**CALIFORNIA COASTAL COMMISSION**

**STAFF REPORT: DE NOVO HEARING**

**Application Number:** A-3-MCO-17-0038

**Project Description:** Driveway improvements, including a retaining wall, at an existing single family residence

**SITE PLAN**

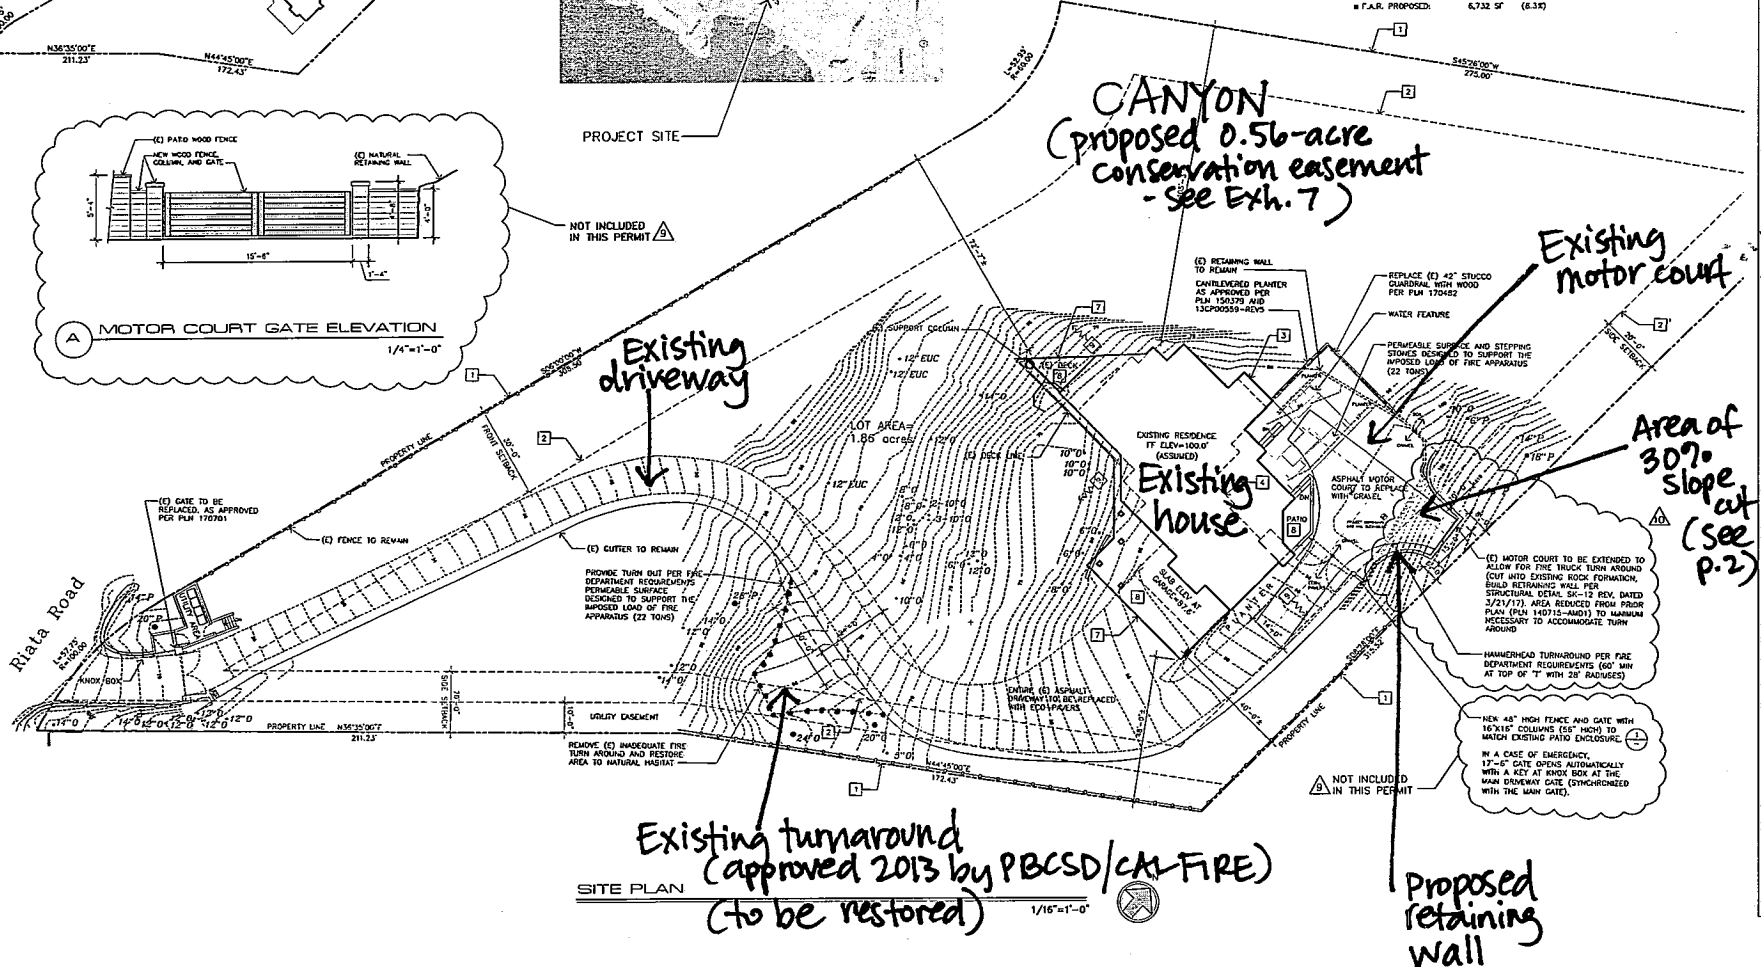
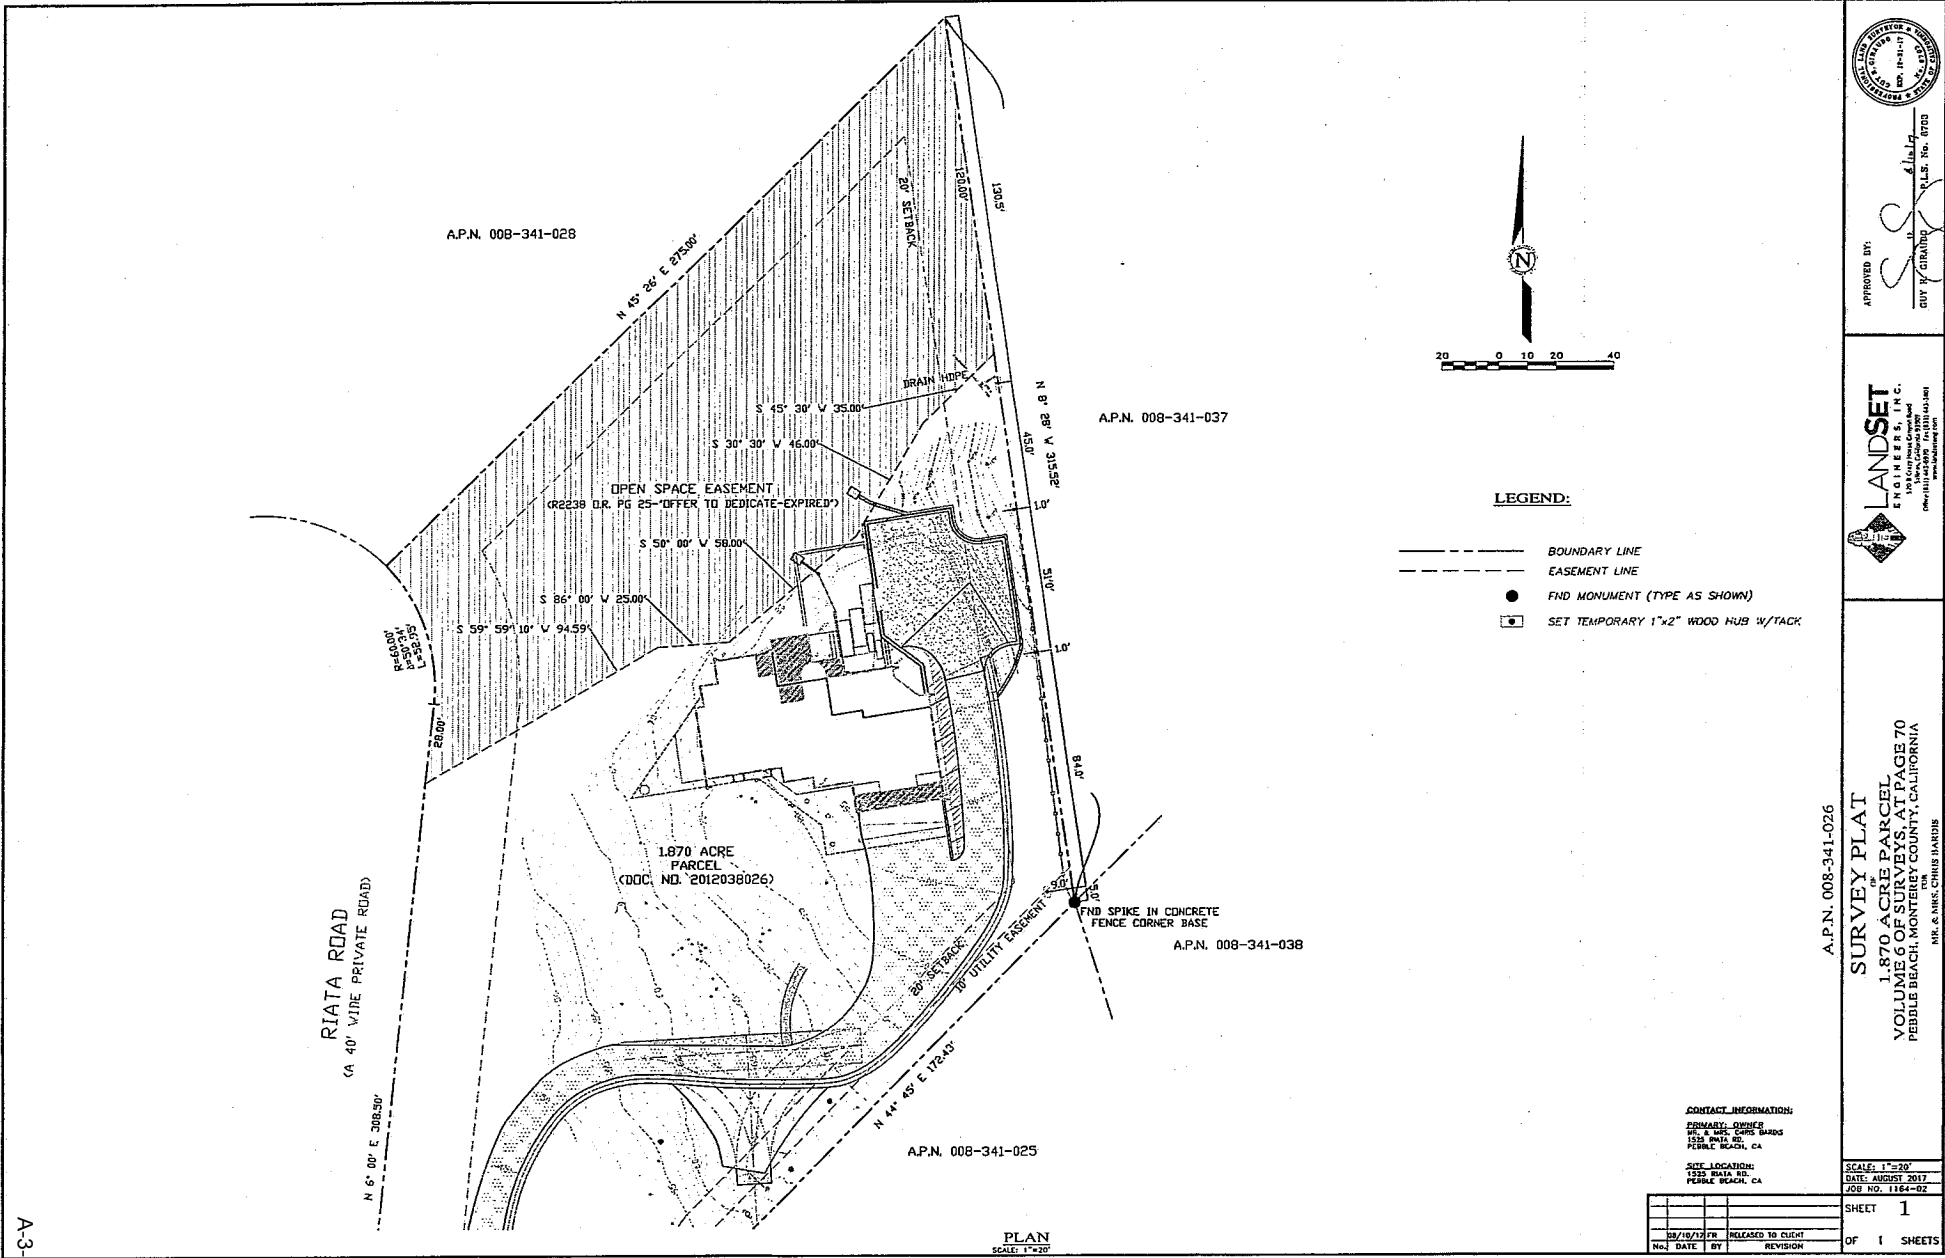
The proposed project involves a 458-square-foot cut into 30 to 60 percent slopes on the east side of the motor court to accommodate the 60-foot-wide (at the top of the "T") emergency access hammerhead turnaround required by PBCSD/CAL FIRE (see **Exhibit 3** for project plans). Because the project involves cut and excavation of 30+ percent slopes, the LCP requires a finding that no feasible alternative exists that would allow development on slopes less than 30 percent or that the proposed project better achieves LCP objectives as a whole than other alternatives.

The Applicant surveyed the site and prepared plans for both locations to demonstrate feasibility for the turnaround. Both locations would necessitate impacts to 30+ percent slopes in the form of cut (motor court: 458 square feet in size requiring 125 cubic yards of cut) or fill (garage area: 785 square feet in size requiring 104 cubic yards of fill). Both locations would necessitate retaining walls of roughly the same length (motor court: 68 linear feet; garage area: 65 linear feet) to support the turnaround. The 30+ percent slope areas that would be impacted under both options are shown on page 2 in **Exhibit 3** and in **Exhibit 6**. In terms of driveway/turnaround surface area, the survey results show that the garage area presents a grade differential that, absent re-grading and flattening of the existing driveway, would cause a fire truck to bottom out while turning. In contrast, the motor court area would not necessitate any additional grading or flattening (aside from the hillside cut to accommodate a wide enough hammerhead).

The Del Monte Forest LCP protects water quality in the Carmel Bay, among other ways, by requiring residential development to be limited to a maximum of 9,000 square feet of impervious surface coverage (CIP Section 20.147.030.A.1.b – see **Exhibit 8**). Existing impervious surface coverage on the site is 17,185 square feet. The proposed project includes removal of existing asphalt and replacement with pervious pavers over the entirety of the approximately 530-foot long driveway (including the motor court). This change will result in a total impervious surface coverage on the site of 6,532 square feet, consistent with the requirements of CIP Section 20.147.030.A.1.b. **Special Condition 1(e)** requires final plans that show this reduction in impervious coverage.

- a. **Motor court.** The hammerhead-style turnaround shall not exceed 60 feet in length at the top of the hammerhead and shall be clearly shown in site plan view in the motor court and patio area.

- b. **Retaining wall.** The Final Plans shall show a retaining wall over the entirety of the cut slope. Associated drainage features shall be in the minimum footprint necessary to address runoff at the wall.

- e. **Pervious pavers.** The Final Plans shall show the entirety of the existing driveway (with the exception of the existing turnout area that will be restored to native habitat pursuant to **Special Condition 1(d)** above), motor court, and patio to be converted from impervious paving to pervious material(s), including but not limited to pervious pavers, decomposed granite, etc.
